# LECKHAMPTON WITH WARDEN HILL NEIGHBOURHOOD DEVELOPMENT PLAN

Response on behalf of Miller Homes

JBB7795.C8323  
Final  
11 April 2023

Figure 6-1 Extent of flooding – Leckhampton (<https://check-long-term-flood-risk.service.gov.uk/map>)

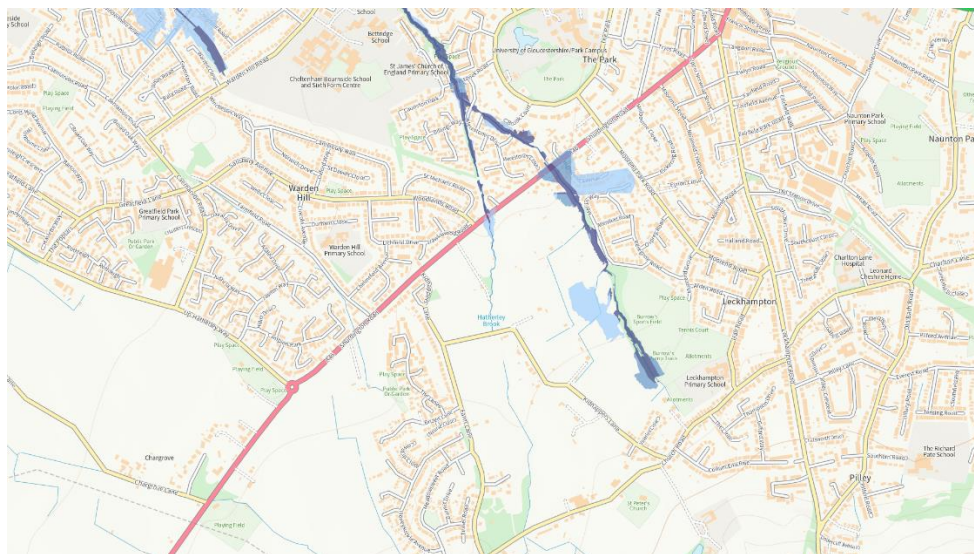
6.3 Area 6 largely comprises land within areas at risk of flooding and so would not constitute developable land on any reasonable assessment. RPS would also question whether the small areas ‘fingers’ extending in a north-westerly and easterly direction actually form part of Hatherley Brook or are at risk of flooding which is very narrow in extent, as can be seen in the extract below. This part of the policy has not properly been evidenced and justified.

6.4 On this basis, **the identification within Appendix 3 of Area 6 is not justified on the available evidence. No evidence has presented in the LWHNDP to justify any incursion of these protections in a lateral direction west or east to include land beyond Hatherley Brook corridor.**
